Hamilton Square

Hamilton Square LLC
Novato, California

Two-Story Alternative Study
May 2017

Elevation Scale and Character: Revised Elevations

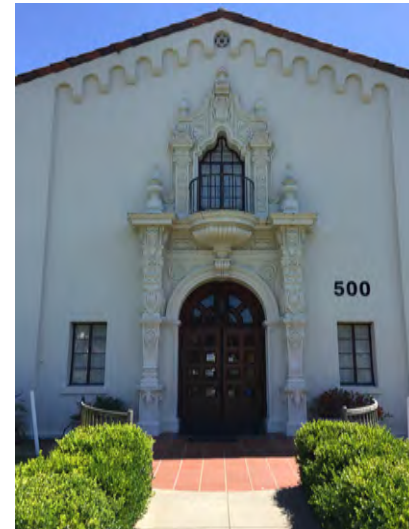
- All elevations are now two stories
- Peak height is ~28' rather than ~34'
- Ranges are 2-3 units wide, rather than 3-5
